APPENDIX A

TECHNICAL SPECIFICATION CHANGES

PLANT VOGTLE - UNIT 1
NRC DOCKET 50-424
OPERATING LICENSE NPF-68
REQUEST TO REVISE TECHNICAL SPECIFICATIONS
10 CFR 50.92 EVALUATION

PLANT VOGTLE - UNIT 1
NRC DOCKET 50-424
OPERATING LICENSE NPF-68
REQUEST TO REVISE TECHNICAL SPECIFICATIONS
INSTRUCTIONS FOR INCORPORATION

FIGURE 3.1-1 REQUIRED SHUTDOWN MARGIN FOR MODES 3 AND 4 (MODE 4 WITH AT LEAST ONE REACTOR COOLANT PUMP RUNNING)

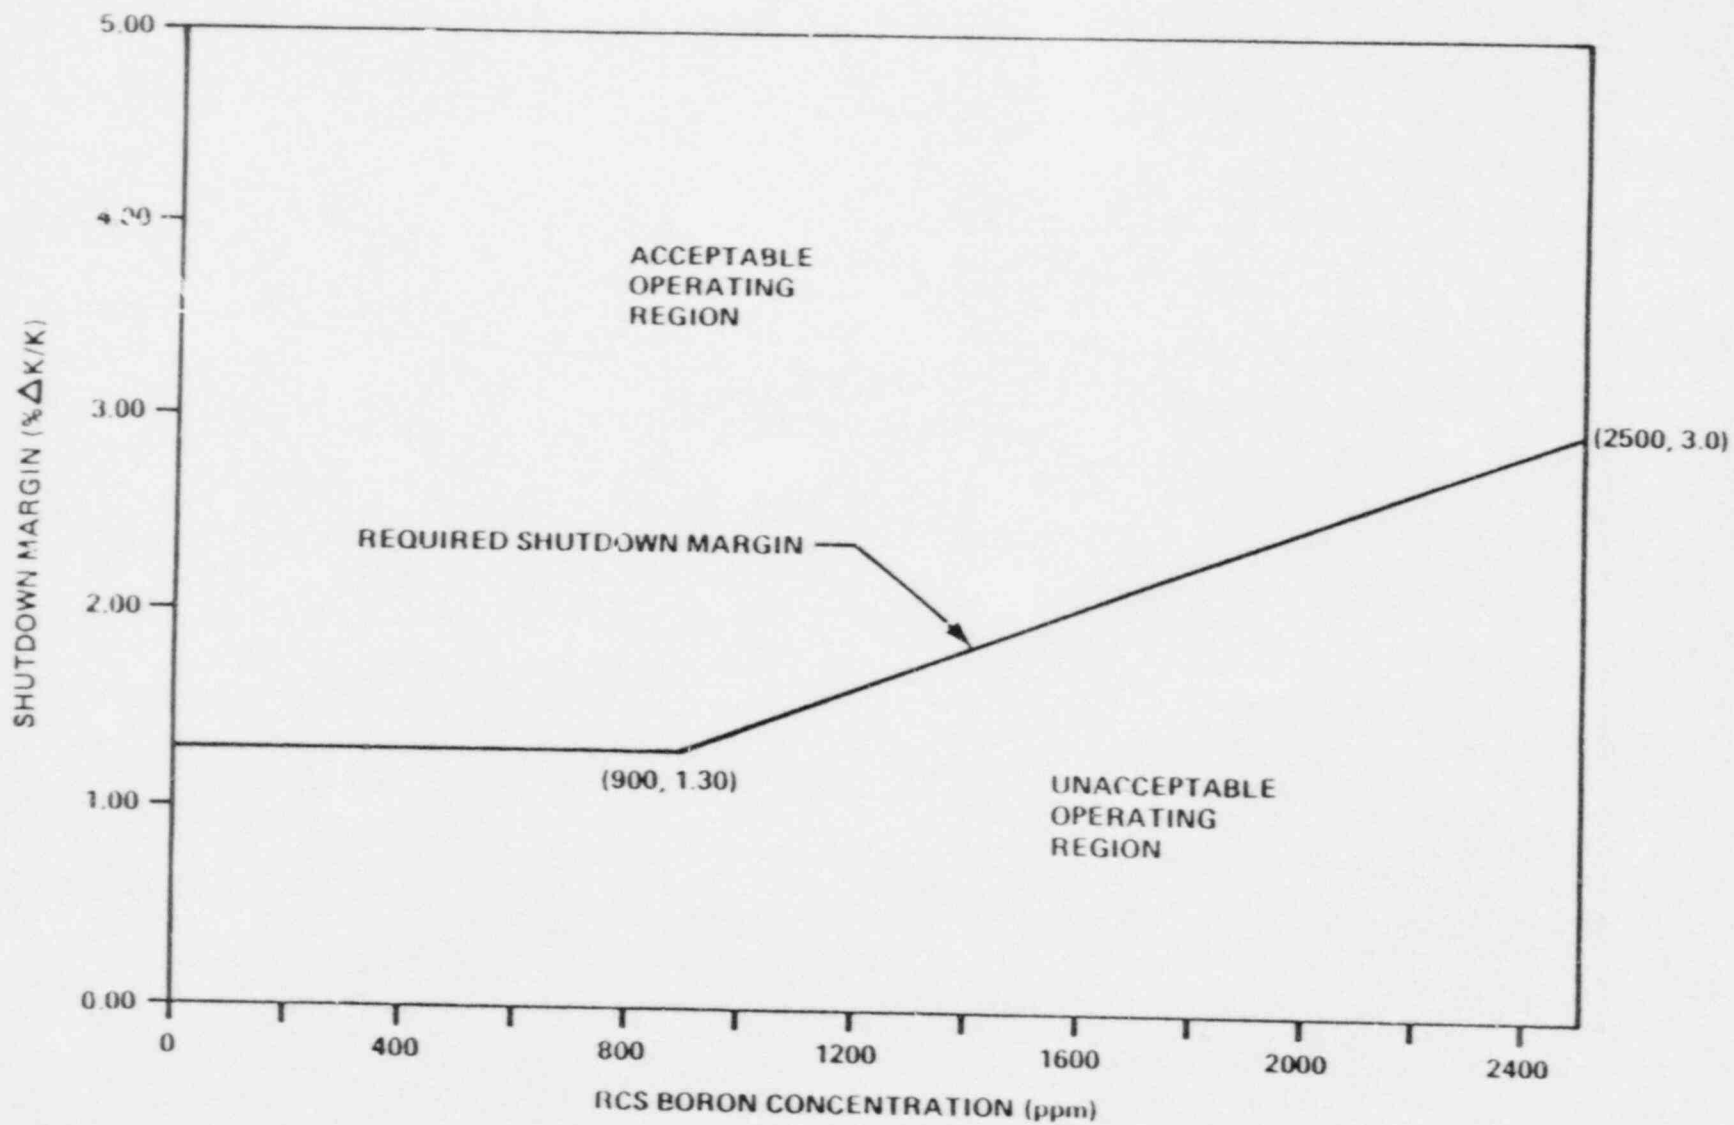
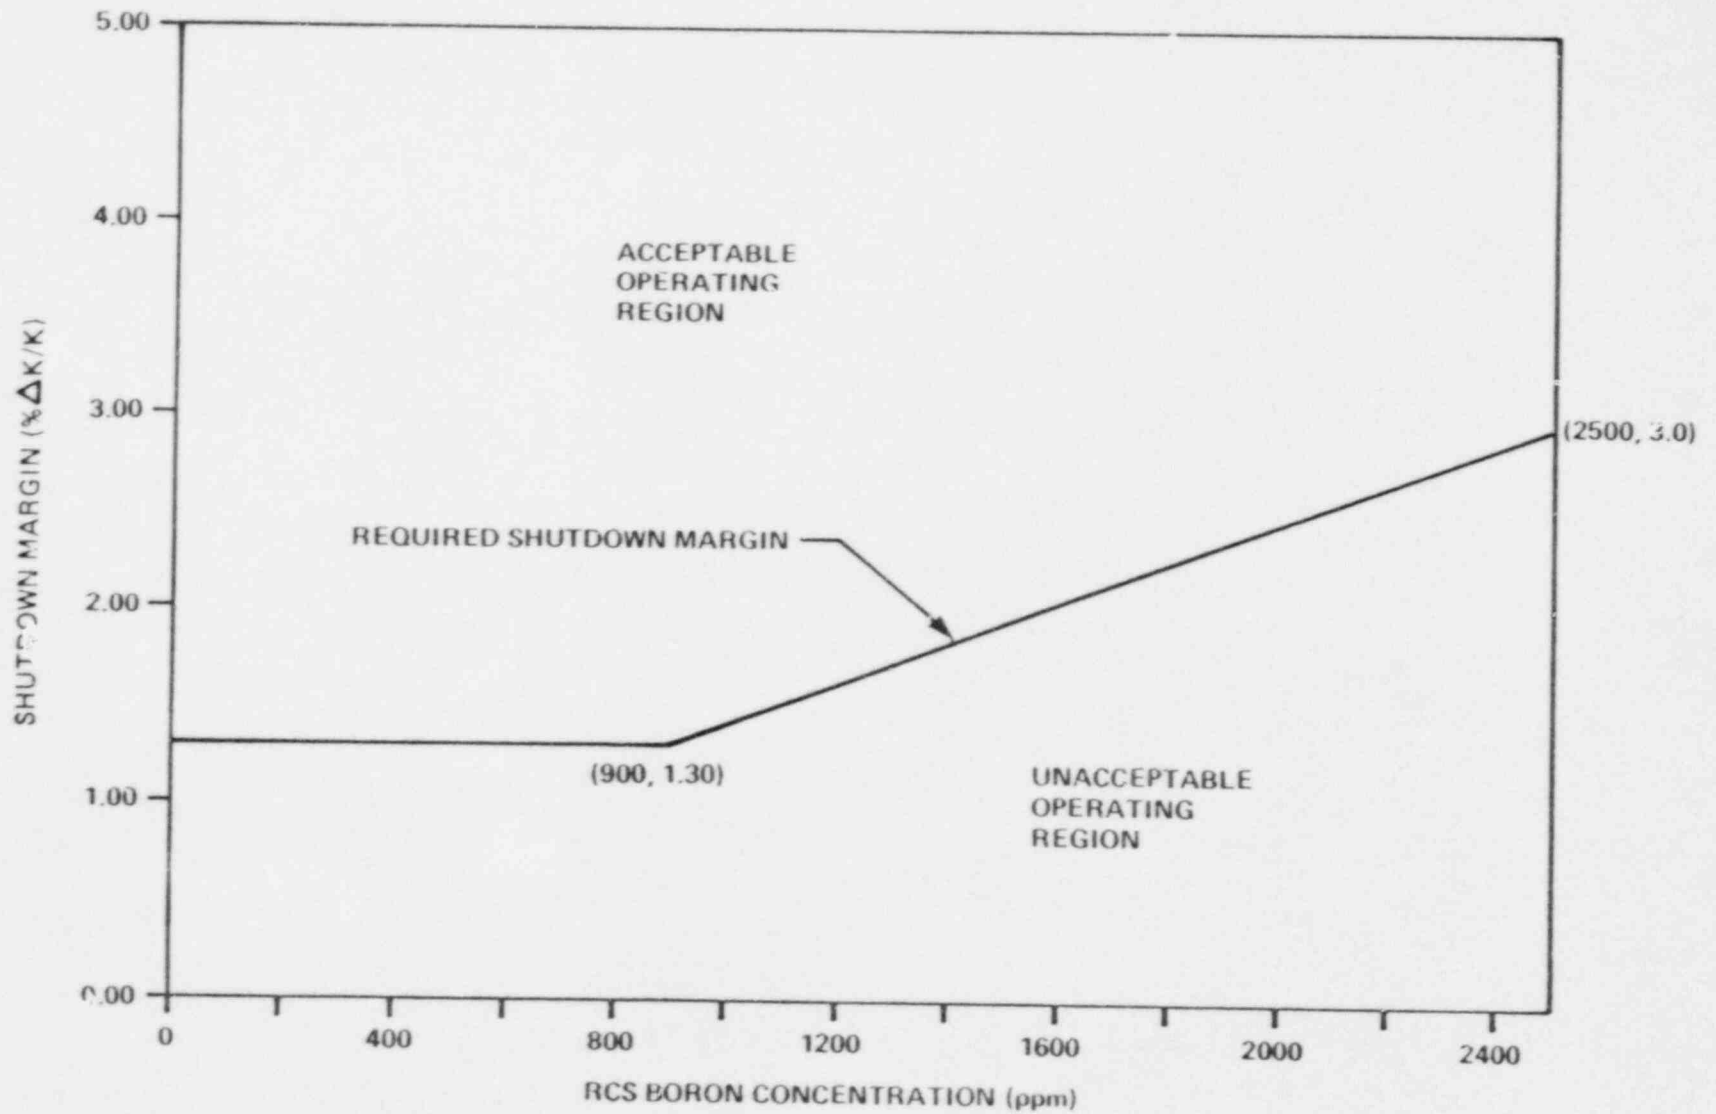
The boron dilution analyses for MODES 3, 4, and 5 resulted in revised curves of required shutdown margin as a function of RCS boron concentration. These curves are designed to ensure that the operator will have at least 15 minutes of response time after receipt of the high flux at shutdown alarm before shutdown margin is lost. These curves appear in Technical Specification Figures 3.1-1 and 3.1-2 and have been revised to accommodate the higher critical boron concentrations expected for future cycles. The reanalyses of boron dilution assumes that the high flux at shutdown alarm setpoint is set at 2.30 times background (Technical Specification Table 4.3-1, table notation 9). This setpoint change provides relief from excessively high shutdown margin requirements at higher RCS boron concentrations and provides margin between the setpoint and potential background noise signals that could cause spurious high flux at shutdown alarms.
